Subject: 7914 E Heartwood Dr. #13 – Plan Review Comments

Kimball Engineering has completed the first review of the proposed 7914 E Heartwood Dr. #13 project located in Eden, Utah. This review was based upon the following:

## Plan Review Comments

**Project Name:** 7914 E Heartwood Dr. #13

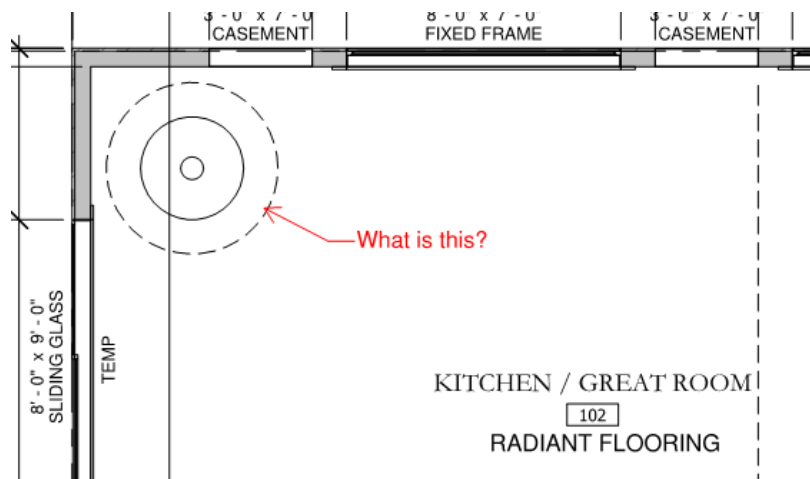
- A5. Please provide a landing and stairs for the exterior door from the main level great room that conforms to the current code.
- A1. Please clarify what is shown in the corner of the great room. A snap shot is included below to clarify the item in question. If it is a fireplace please note what type of fireplace it is along with the listing and manufacturer's installation instructions per IRC R1004.1. Also clarify the air supply being provided for combustions per IRC R1006. Please also show how the fireplace will be exhausted.
